LESSONS IN UNIVERSAL DESIGN AND THE AI-IC

Clarence D. Olsen, AA, NCARB

Cohen Hilberry Architects - St. Louis, MO

<p>Tiffany II Residence Habitat For Humanity Date Issued: 4/3/2018</p>	<p>Sheet A-I PLANS Enclosing Laundry Area</p>	<p>Cohen Hilberry Architects (314) 367- 8300 4941 McPherson Ave. st Louis. MO 63108</p>
---	--	--

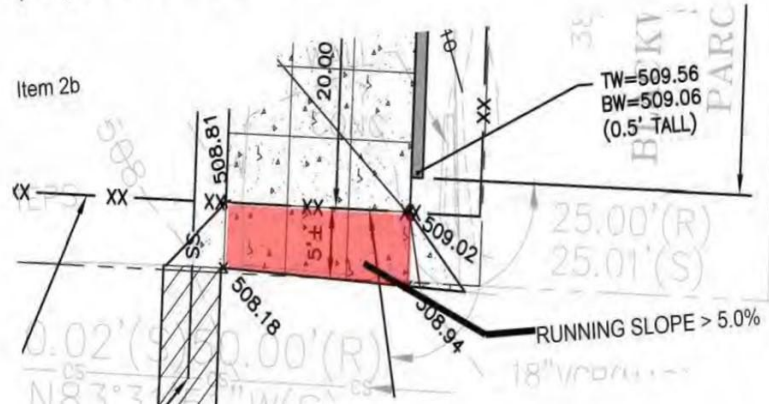
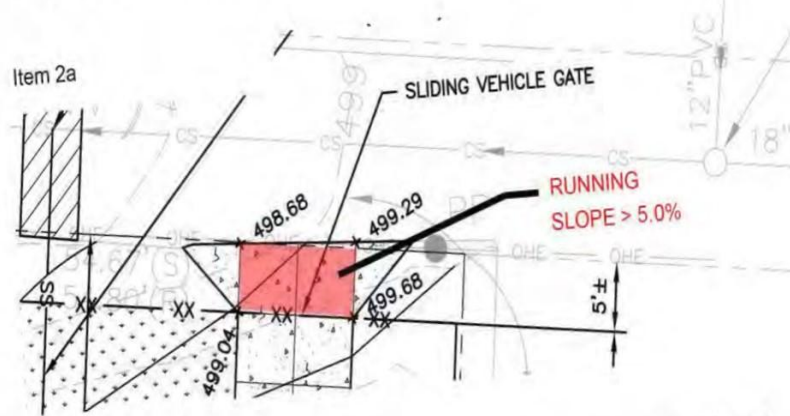
- Highlight Design issue
- Provide Solution**
- Graphic and Written Response

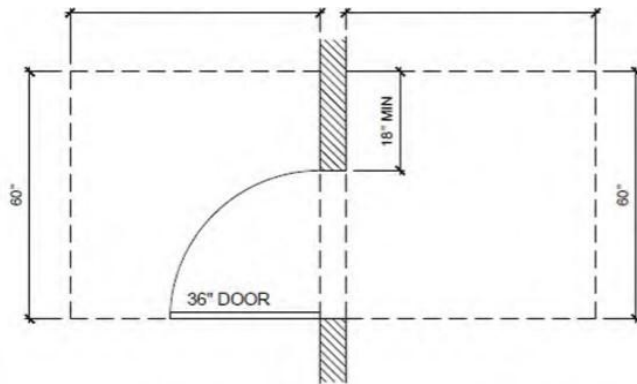
- I. The concrete pathways leading to the parking and the parking pad are all compliant, but there are a few missing grade points at the maneuvering landings. You may want to consider adding points at each corner of the concrete slabs to ensure you meet the 2.0% cross slope in both directions when it is poured. See attached.**

- 2. There is an issue with the running slope of the concrete pads between the parking area and the alley. The running slope is greater than 5.0% on the 3846 and 3861 Folsom properties. This is an issue for residents to take their trash to the alley dumpster. This may require regrading the site to reduce the running slope to an acceptable tolerance. See attached.**

-Project tracking for future reference.
- 3. The accessible ramps serving the home should state that the cross slope cannot exceed 2.0%. The ramp top landing should state that cross slope 2.0% both directions. I do not think this is an issue with the design but the information would be helpful to see.**
- 4. House numbers are not indicated on the elevations. Please verify that they will be provided at front and back of home, 4.0" minimum height letters with 70% color contrast to background,**
- 5. I see a keyed note on the elevations #20 for the ramp describing the decking. Please confirm that decking with have gaps no larger than k".**
- 6. Please confirm the location of the mailbox.**
- 7. Primary entry door does not provide a sidelight. I am considering the main door to**

- 8. Please confirm that the metal threshold on each exterior door is maximum 1/2" high with bevel or W' high with squared edge.***
- 9. Please confirm internally illuminated doorbell provided that is wired to allow retrofit of visible interior signal. I am considering the main door to the front porch the primary door in this situation.***
- 10. The inside of the side entrance door does not provide 60"x60" clear floor space. See***
- 11. attached.***

Please confirm that lighting is provided at each exterior entrance door.

302.1.9.1 Lighting. Provide outdoor lighting either in porch roof/ceiling or with a sconce mounted on the latch Side of the door.

Minimum 100 watt capacity fixture.

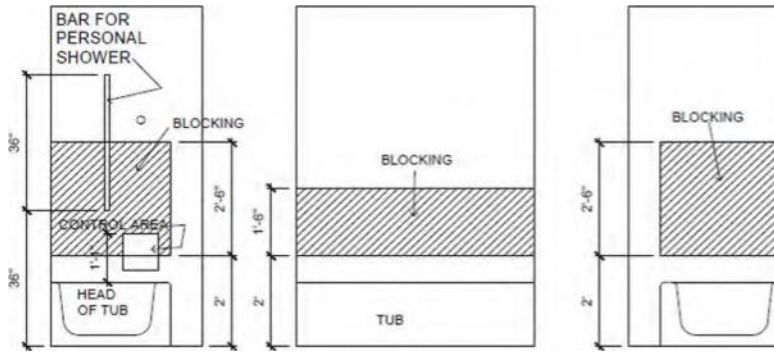
- 15. Linen closet on second floor is too deep for the size of door. Please reduce this closet to 24.0" interior depth maximum. See attached.***

302.1.7 Clear floor space. Provide 5' x 5' maneuvering space inside and outside of entry door. At the exterior side of the door, provide a full turning circle (60" radius) of level space clear of the door swing. See illustration 302a.

302a Approach areas for primary no-step entry
